Kitchener Drain Project - Wastewater Component

Request for Clarifications

Rehabilitation (Rebuild) of Tanta Wastewater Treatment Plant 100,000 m³/day

Ref. No./ Contract No.	2/GH/KP/Works/2022
Implementing Entity	Gharbia Company for Water and Wastewater
Loan Operation No.	N° FI 87454 Serapis No 2017/0090
Issue Date	December 2023

Drawing No. 14: Location of Services

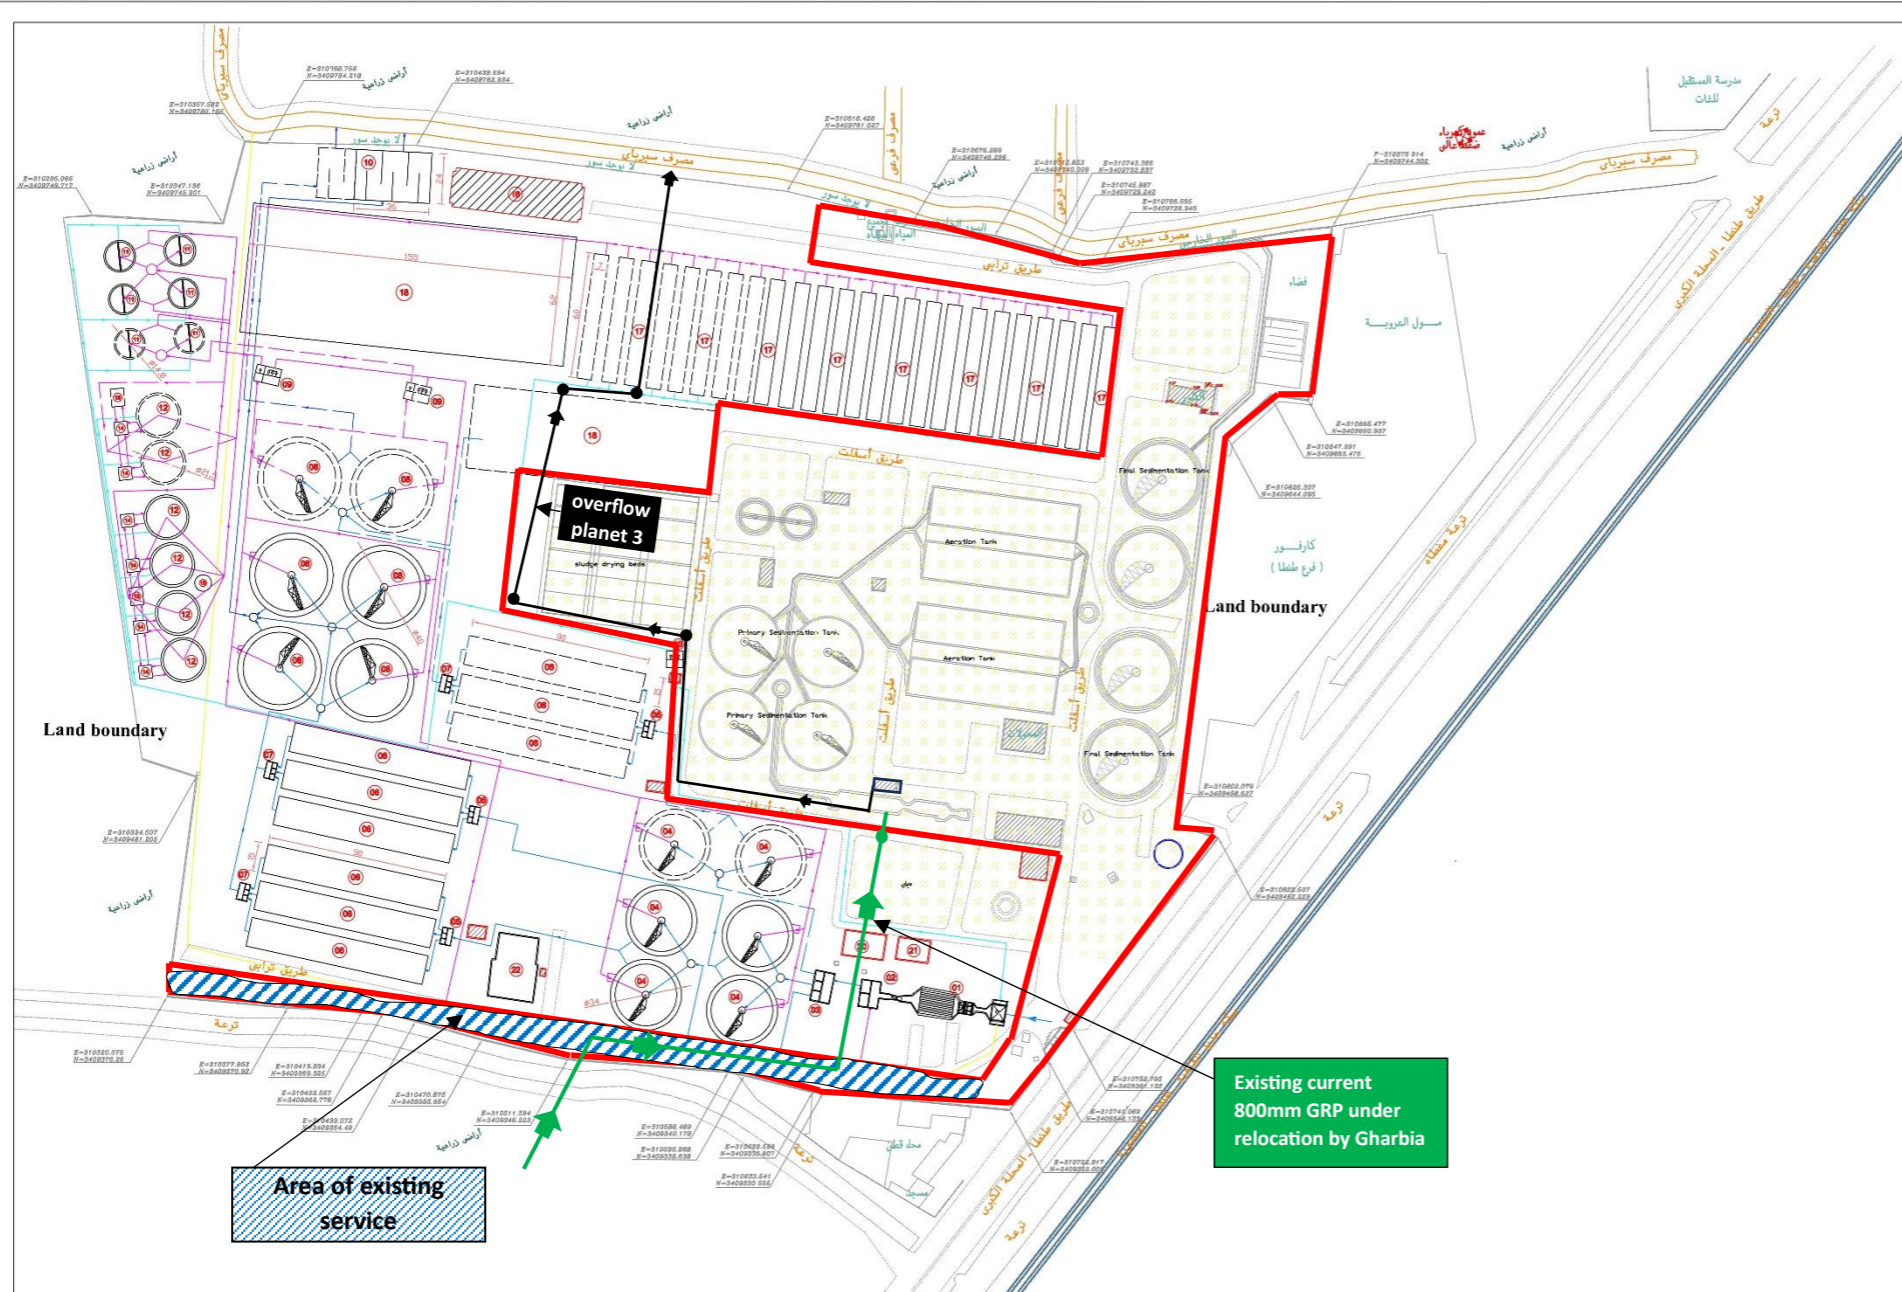
Q.9	<p>Please provide drawing for underground existing piping and cables</p> <p>Will the surface cables next to the fence be rerouted because they are located in the same path of the new road and they are the feeder of the current station</p> <p>Please confirm that re-routing of any existing infrastructure (piping, cables, trenches, etc.) shall be out of the tender scope and the site shall be handed over free of any obstacles above ground and underground.</p> <p>"According to site visit on Thursday of 19 October: We noticed the following: 1- Force main pipe of 800 mm for stream No. (3) intersects the new plant headworks shown in (tender general layout) drawing. 2- Bypass pipe for stream No. (3) intersect the new drying beds shown in (tender general layout) drawing. Please confirm that the relocation of these lines is out of our scope."</p>	<p>Tanta 1&2 has recently been demolished which has removed the majority of services in the area. The Employer believes the site to be free of any existing infrastructure except for the following services which are shown on attached drawing No. 14 in <u>Annex#5</u>.</p> <ul style="list-style-type: none"> • the 800mm dia. pressure main which currently runs through the location of the proposed headworks, • The services which run down the southwest side of the site and, • the overflow pipe which runs through the proposed location of the future drying beds.

No.	Question	Answer
		<p>Of the above services the 800mm dia. pipe will be the only service relocated. This will be done by the WSC before Contract signature. The other services will remain in place. However, this does not relieve the Contractor of performing normal due diligence to protect the services. Any available services data can be obtained from the Gharbia WSC and the Contractor is reminded that the Contractor needs to ensure the site is free of services before commencing work.</p>
Q.10	Please provide client approved vendor list.	<p>No vendor list will be provided.</p> <p>Please refer to: Section "Scope of Supply of Plant and Installation Services by the Contractor", and "Employer Specific Requirements" "All electro-mechanical equipment shall be of heavy-duty performance, and to standards applied in North America, Europe, Japan, or local manufacturing origin".</p>
Q.11	<p>Section VII, WWTP Facilities Requirements, Sludge Treatment Scheme</p> <p>Despite the size of the treatment plant (150 mld in its final phase, current tender is 100 mld), the plant is a CAS without sludge stabilization (neither anaerobic nor aerobic sludge digestion) and without mechanical dewatering, but only thickening and sludge drying beds shall be offered.</p> <p>Considering the huge area required for the sludge drying beds, especially considering its final extension, we recommend implementing mechanical sludge dewatering, e.g. belt presses</p> <p>The client is requested to reconsider whether mechanical sludge dewatering shall be mandatory to all bidders or not?</p>	<p>For the current contract, it is confirmed that:</p> <ol style="list-style-type: none"> 1. Average flowrate = 100,000 m³/d. 2. No sludge stabilization (neither anaerobic nor aerobic sludge digestions). 3. Only gravity thickeners and drying beds are considered for the sludge processing. 4. Mechanical sludge dewatering is not considered for the current contract.
